**MINUTES
OF
IOWA DOT SPECIFICATION COMMITTEE MEETING**

November 18, 2021

The Specification Committee met on Thursday, November 18, 2021, at 9:00 a.m. Tom Reis, Specifications Engineer, opened the meeting. The items were discussed in accordance with the revised agenda dated November 10, 2021:

REVISION	3	04-27-20
MODIFIED		
STANDARD ROAD PLAN		
PM-110		
SHEET 1 of 4		
<small>MODIFICATIONS: ADDED BLC6, BLC8, SLW6, ELY6, BLY6, DCY4, CHW12, and LWY12. Added new possible contract items and tabulation.</small>		
LINE TYPES

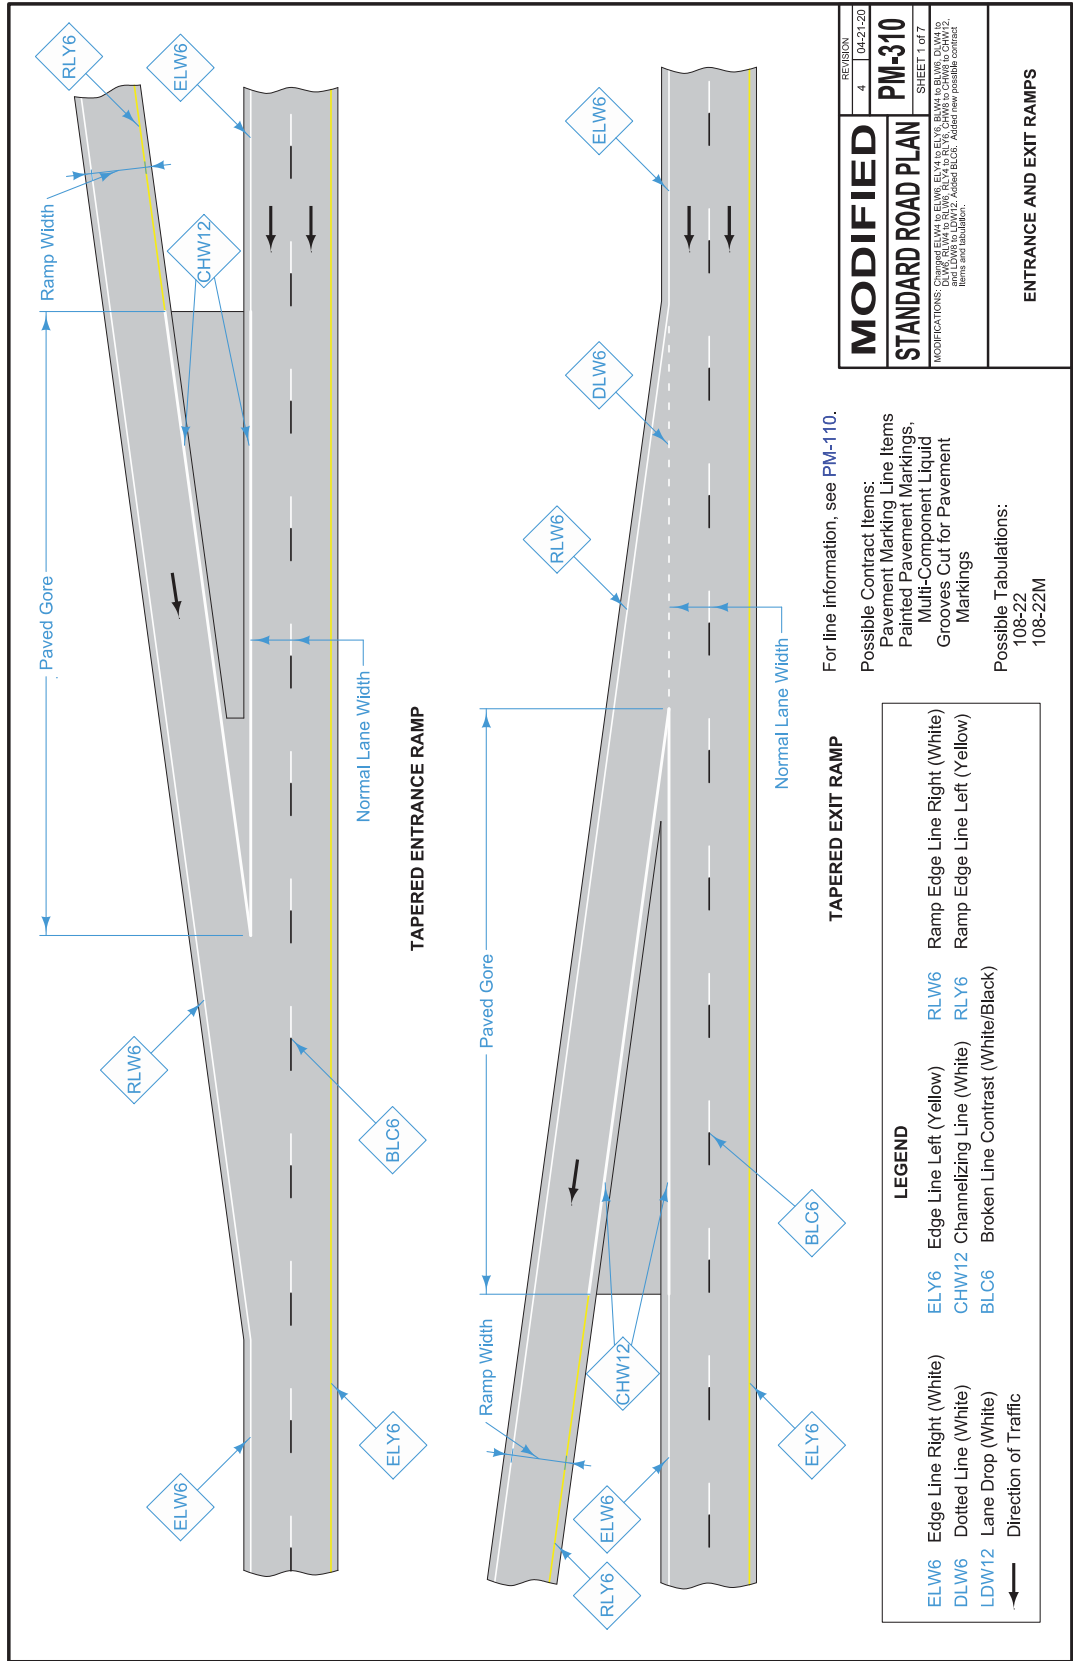
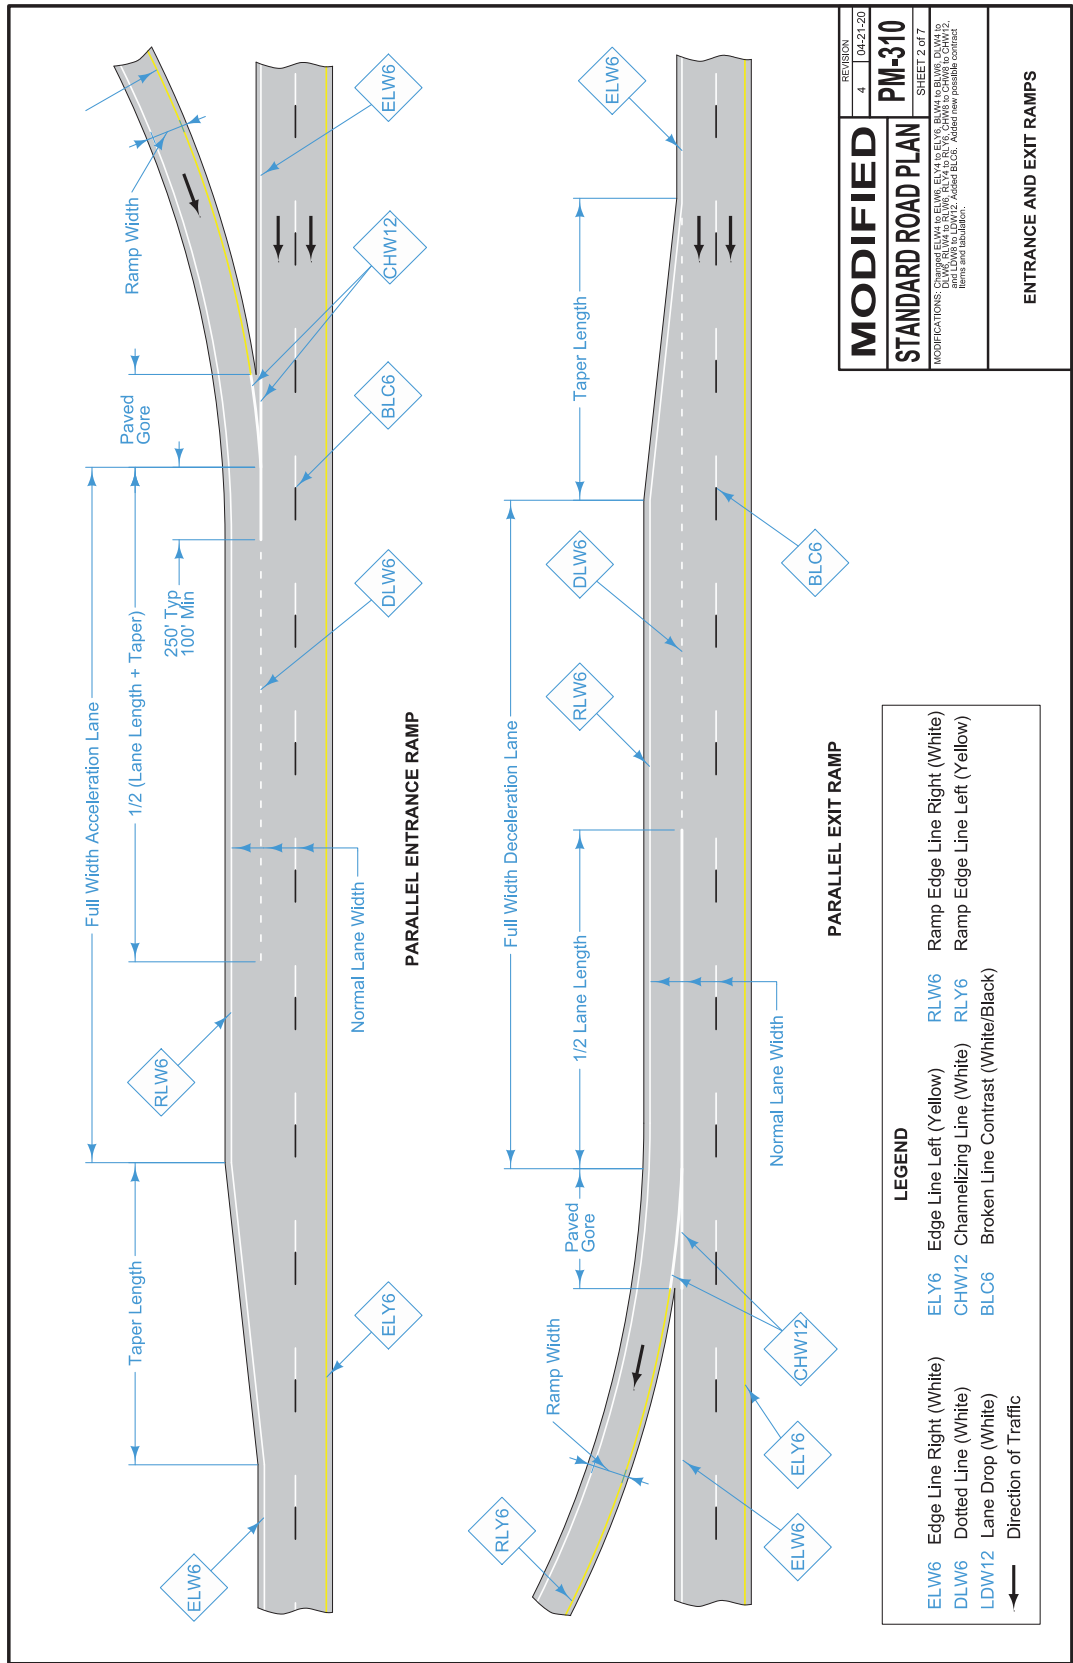
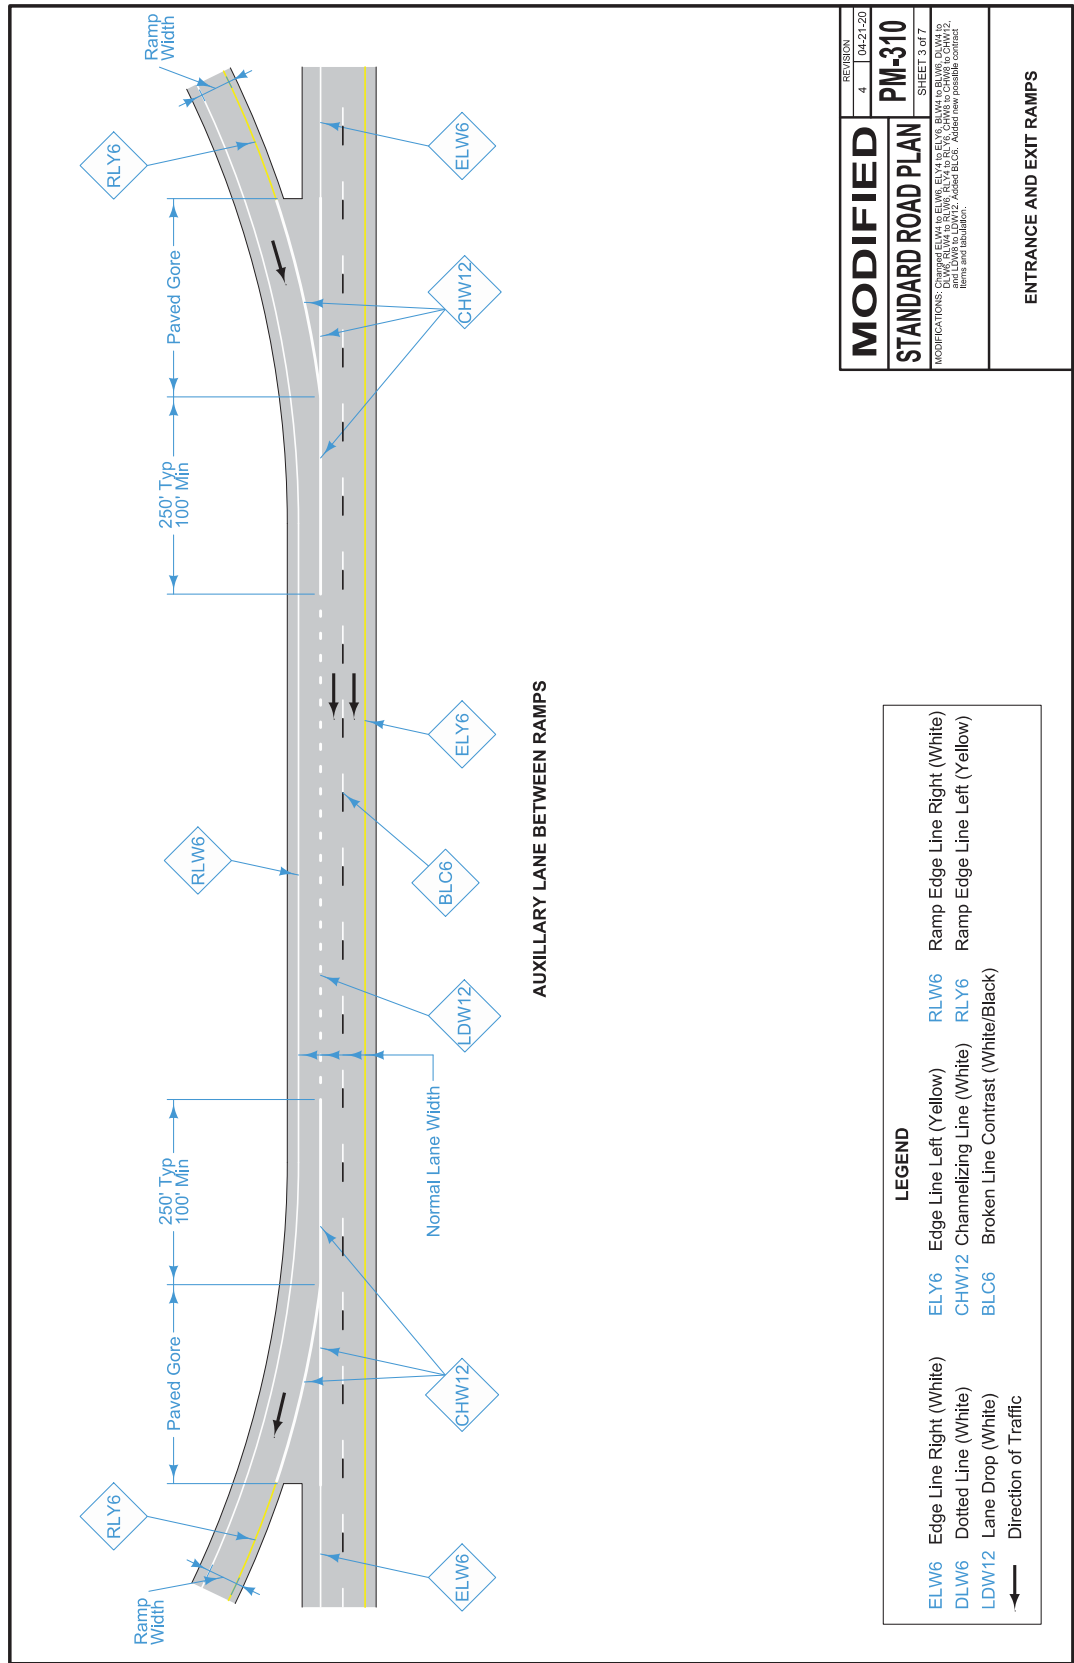
- j. Contrast ratio of 0.98 or greater when measured on a black/white drawdown card at 15 mils WFT application rate.
2. Provide shadow lane line markings (legend BLB6 or BLC6) according to attached modified Standard Road Plans. Black epoxy should satisfy color chip 37038 of Federal Standard 595B and have similar quality as the white and yellow multi-component pavement markings. An anti-skid material shall be incorporated with the shadow line marking at a minimum rate of 15 pounds per gallon.

Figure 2. ALR Analysis at the Bridges/ Bridge Approaches

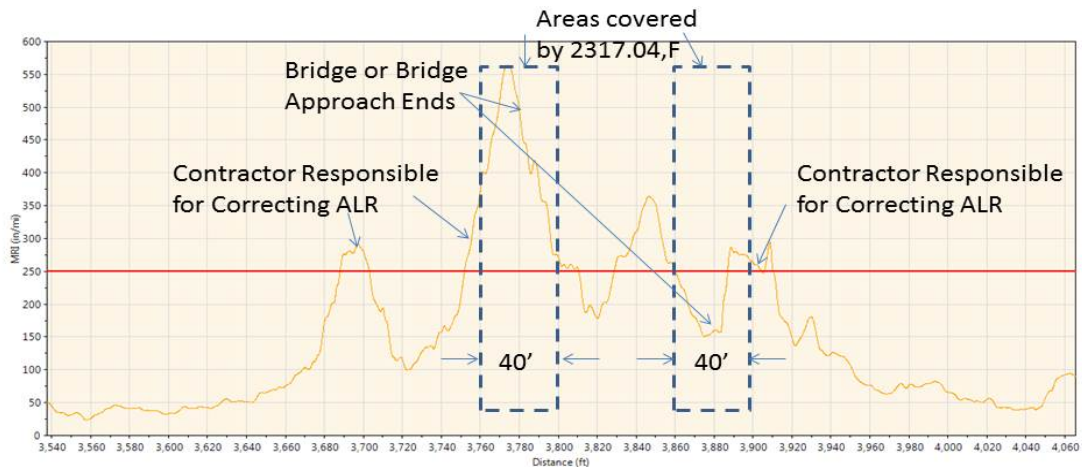
- e) Figure 2 and 3 show examples of how to analyze ALR at obstructions defined in Article 2317.03, B, 2, b of the Standard Specifications.
